EA Project No.: 15-2100

DATE OF ADDENDUM ISSUANCE: Friday, February 2, 2016

Notice: This addendum is issued to all prospective bidders as an amendment to the Drawings and Project Manual for the Park Middle School Addition Project. Bidders shall acknowledge this addendum on the Bid Form. All information contained herein shall be fully incorporated into the Contract Documents as though originally included therein.

Project: Park Middle School Addition Project
EA Project No: 15-2100
LPS Bid Package No: 8369
Date/Time: February 4th, 2016, 4:00 pm
Location: Park Middle School, 855 S. 8th St., Lincoln, NE

1 FIRST FLOOR LIGHTING PLAN
E101 SCALE: 1/8" = 1'-0"

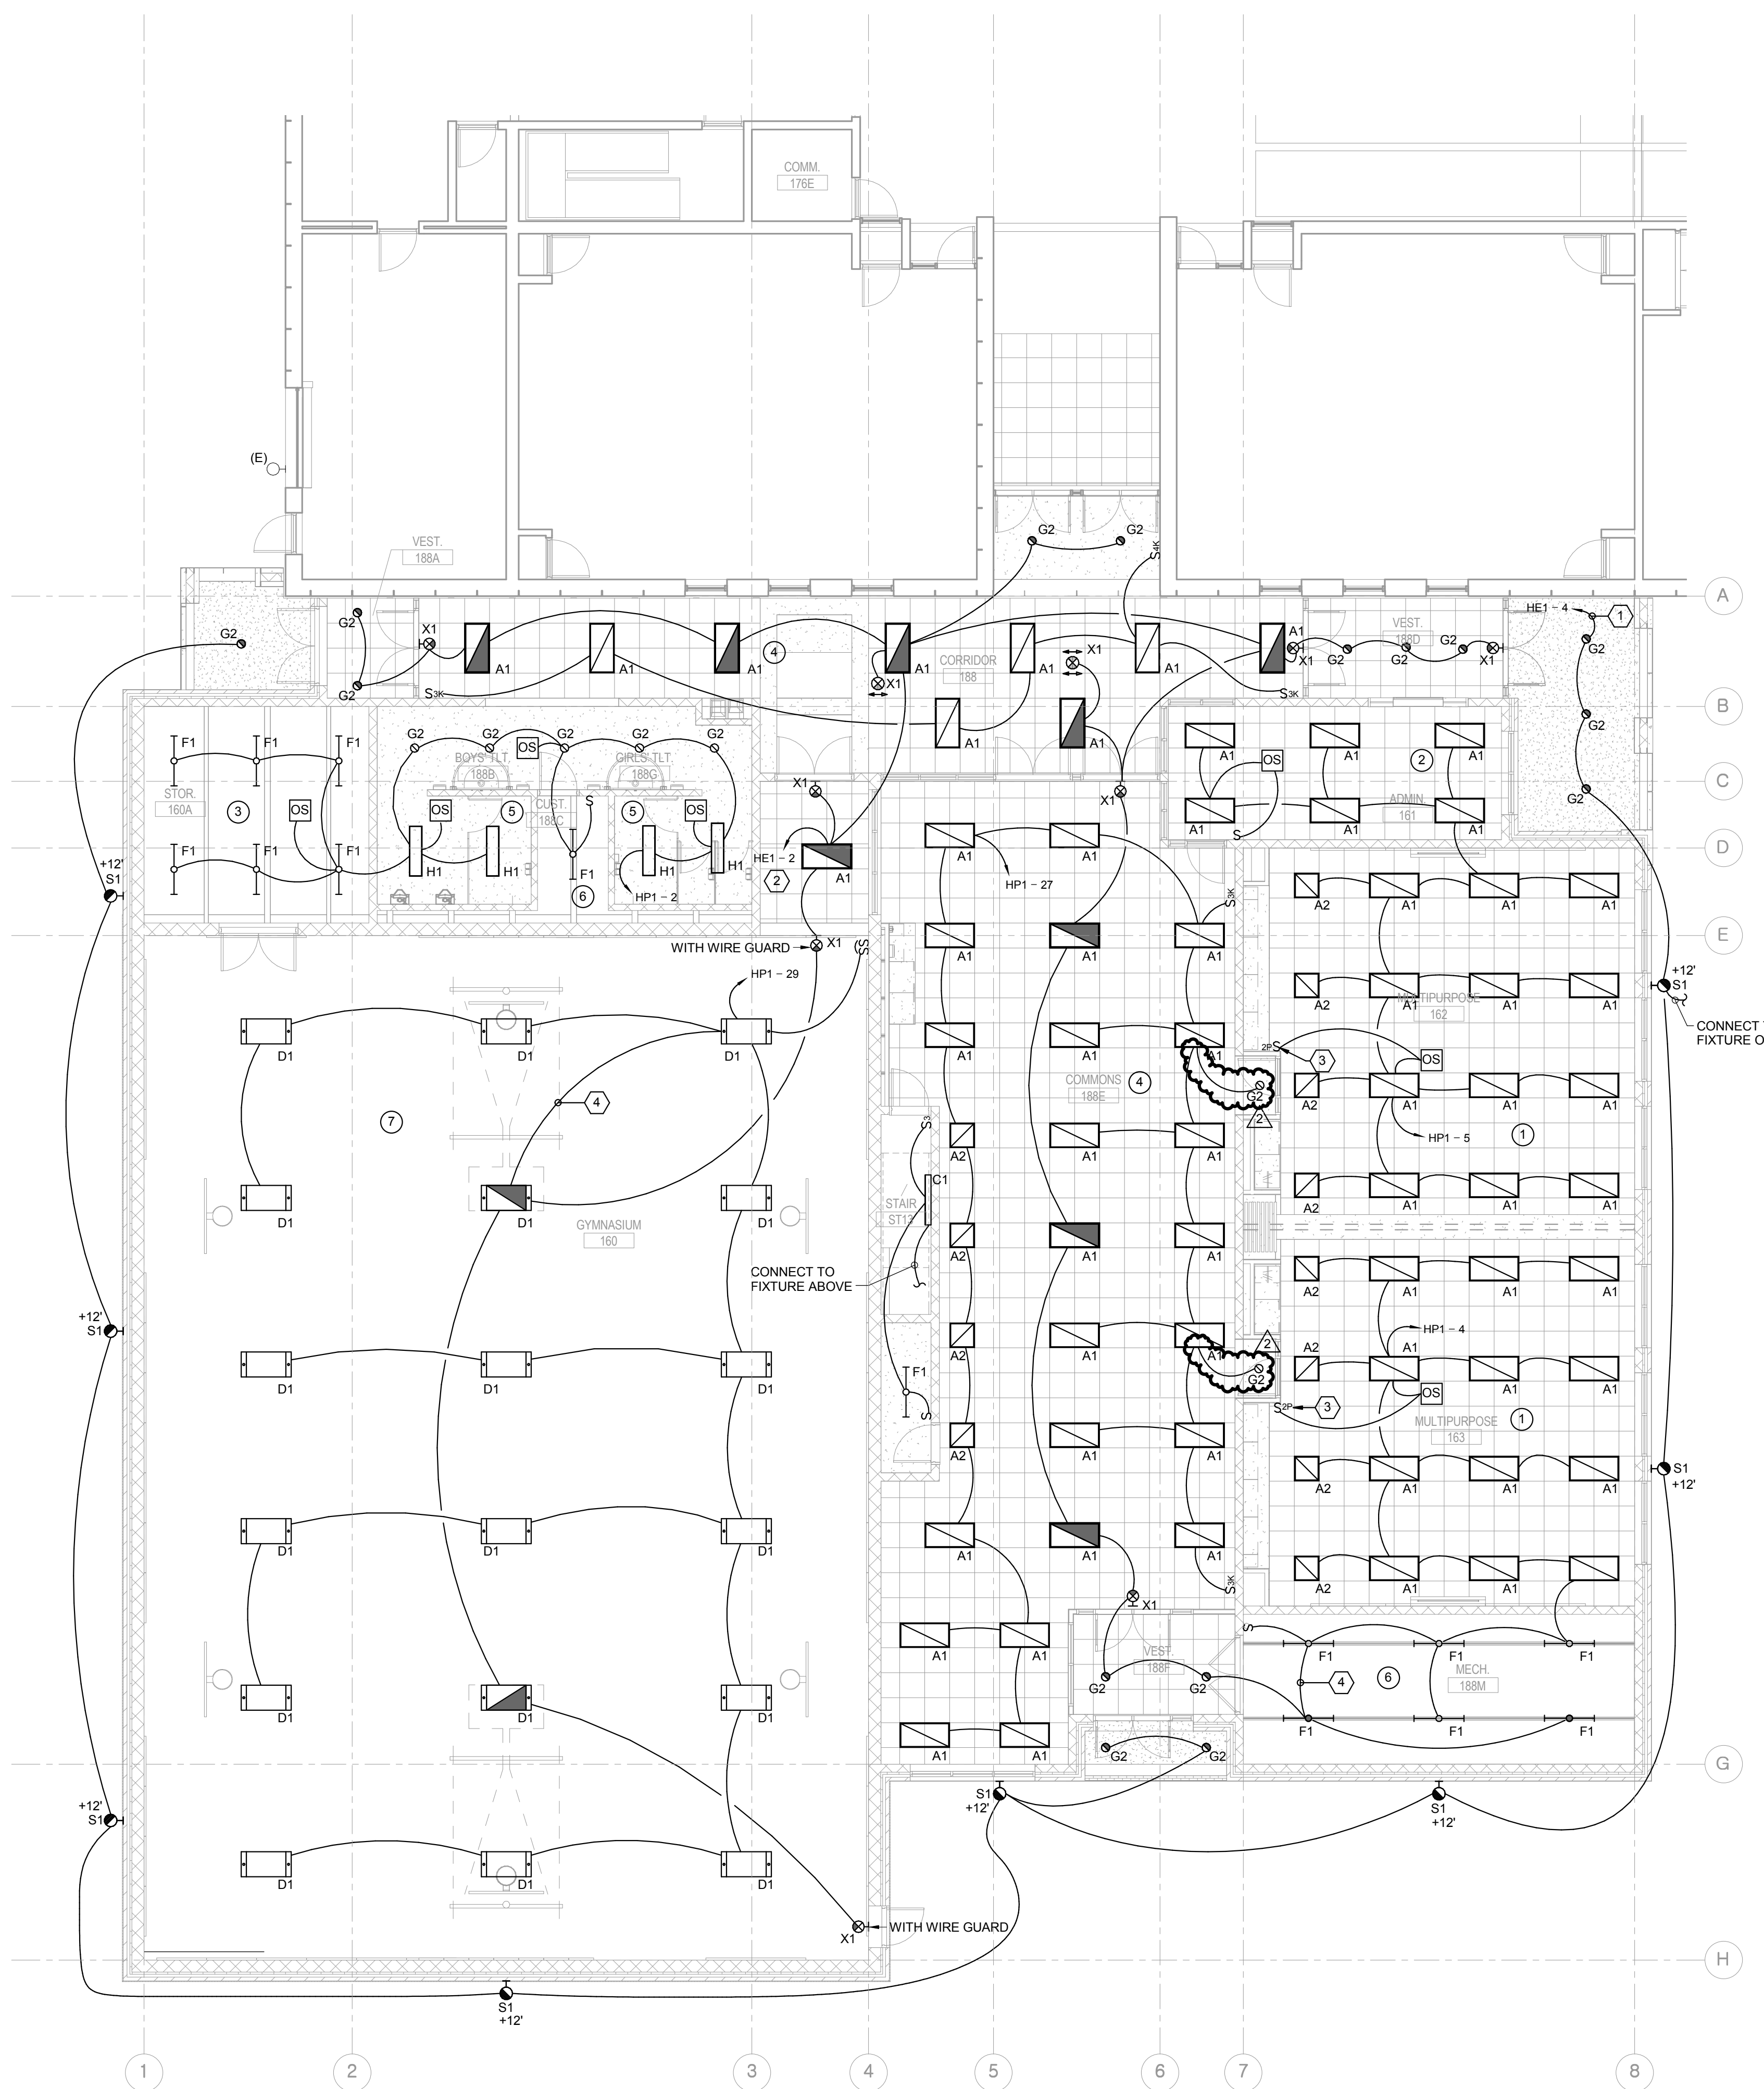
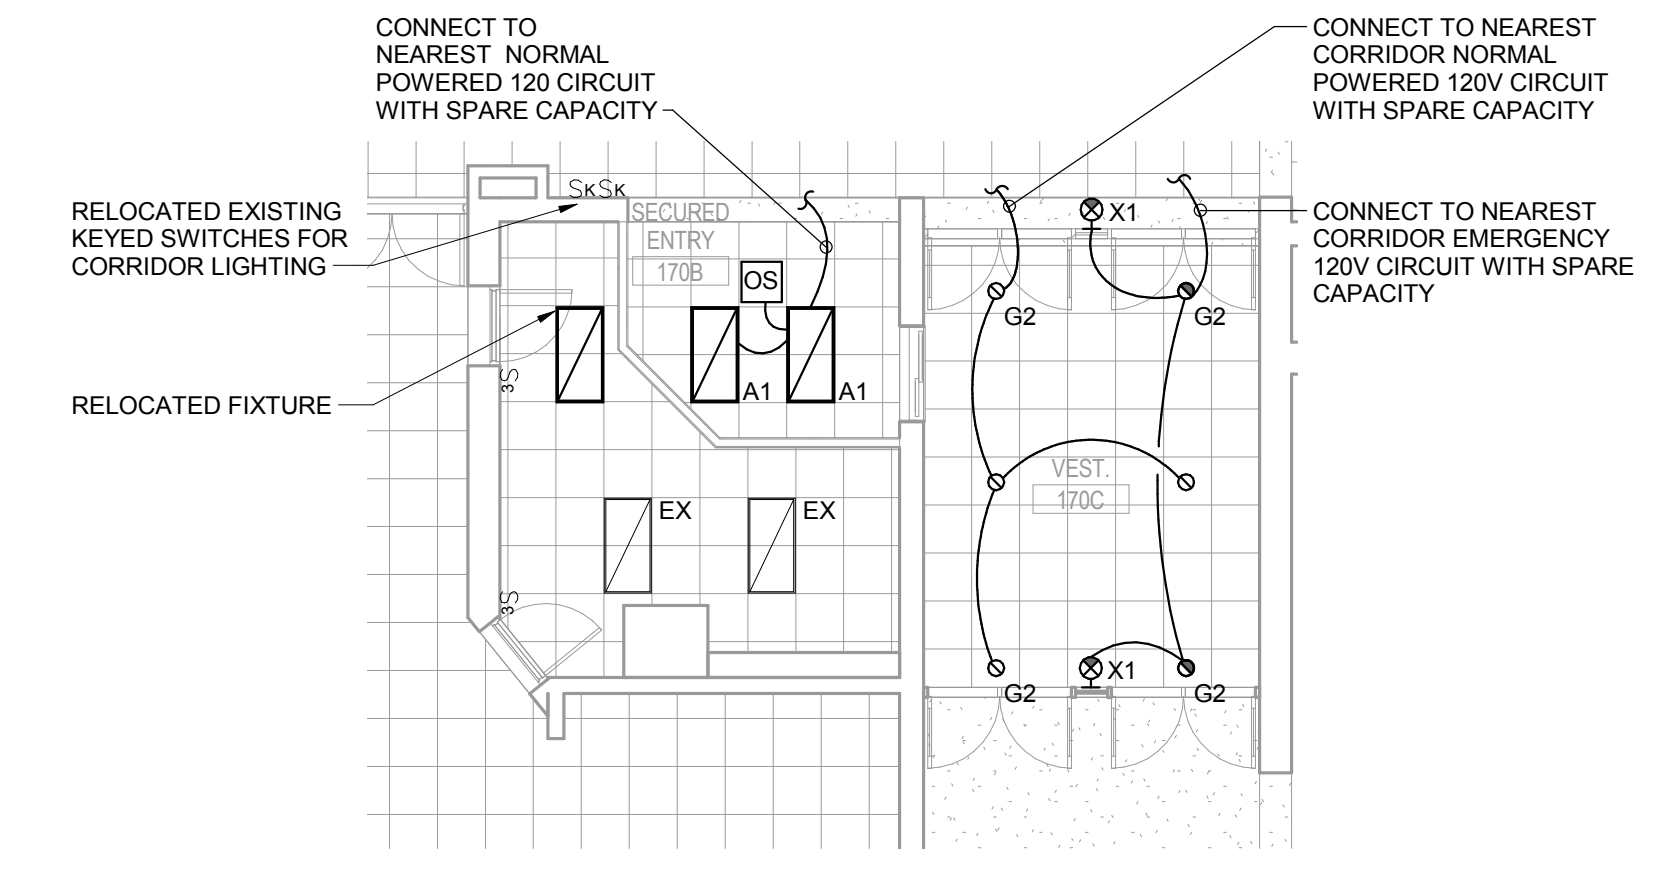
- Item AD-1 Sheet M401
- A. 'Energy Recovery Unit Schedule', Note 1: Add the following to acceptable VFD manufacturers as pre-approved equal: Yaskawa.
- Item AD-2 Sheet M402
- A. 'Pump Schedule', Note 4: Add the following to acceptable VFD manufacturers as pre-approved equal: Yaskawa.
- Item AD-3 Sheet E101
- A. Replace sheet in its entirety with attached Sheet 'E101 – First Floor & Mezzanine Lighting Plan' (see 'Attachment A').
 - B. Clarification: Lighting control design is based on the existing Andover lighting control system, location to be determined.
 - C. Detail 1: Added missing circuitry to type 'G2' fixtures.

- D. 'Key Notes': Delete notes 5, 6, and 7 regarding types 'B1' and 'B2' cove lighting (fixture types 'B1' and 'B2' do not exist in project).
